Project	IEEE 802.16 Broadband Wireless Access Working Group < http://ieee802.org/16 >	
Title	R-FCH for Relay Zone	
Date	2007-04-19	
Submitted		
Source(s)	Kanchei (Ken) Loa, Yi-Hsueh Tsai, Yung-Ting Lee, Hua-Chiang Yin, Shiann-Tsong Sheu, Youn-Tai Lee, Frank C.D. Tsai, Chih-Chiang Hsieh, Heng-Iang Hsu Institute for Information Industry 8F., No. 218, Sec. 2, Dunhua S. Rd., Taipei City, Taiwan.	Voice: +886-2-2739-9616 loa@iii.org.tw
	[add co-authors here]	
Re:	IEEE 802.16j-07/013: "Call for Technical Comments Regarding IEEE Project 802.16j"	
Abstract	This contribution provides R-FCH	
Purpose	Text proposal for 802.16j Baseline Document	
Notice	This document has been prepared to assist IEEE 802.16. It is offered as a basis for discussion and is not binding on the contributing individual(s) or organization(s). The material in this document is subject to change in form and content after further study. The contributor(s) reserve(s) the right to add, amend or withdraw material contained herein.

R-FCH for Relay Zone

Figure 3a OFDMA FCH allocation for all FFT sizes except 128

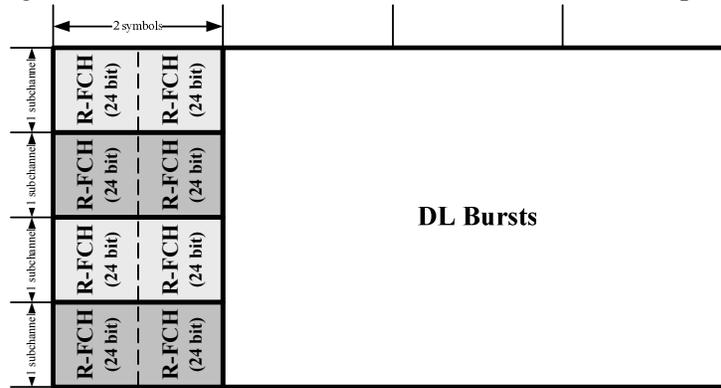
In IEEE 802.16j-026r3, there are three issues in section 8.4.4.7.3 R-FCH channel:

- (1) The subchannel allocation of R-FCH in RS_Zone with FUSC or AMC permutation is not defined
- (2) FEC Code type and modulation type is not flexible enough.
- (3) RS-Zone prefix format for 128 FFT is not defined whose length is only 12 bits.

If RS_Zone is FUSC or AMC permutation, the R-FCH shall be allocated as follows. For FFT sizes other than 128, the first 4 slots in the downlink part of subchannel contain the R-FCH. These slots contain 48 bits modulated by QPSK with coding rate 1/2 and repetition coding of 4. For FFT-128, the first slot in the downlink part of the subchannel is dedicated to R-FCH and repetition is not applied. Figure 3d depicts this structure.

The R-FCH shall be transmitted using QPSK rate 1/2 with four repetitions using the mandatory coding scheme (i.e., the R-FCH information will be sent on four subchannels with successive logical subchannel numbers). For FFT sizes other than 128, **the 24-bit DL Frame Prefix shall be duplicated to form a 48-bit block**, which is the minimal FEC block size. For the case of 128 FFT, the following compressed format shall be used for R-FCH. Before being mapped to the R-FCH, **the 12-bit DL Frame Prefix shall be repeated four times to form a 48-bit block**, which is the minimal FEC block size.
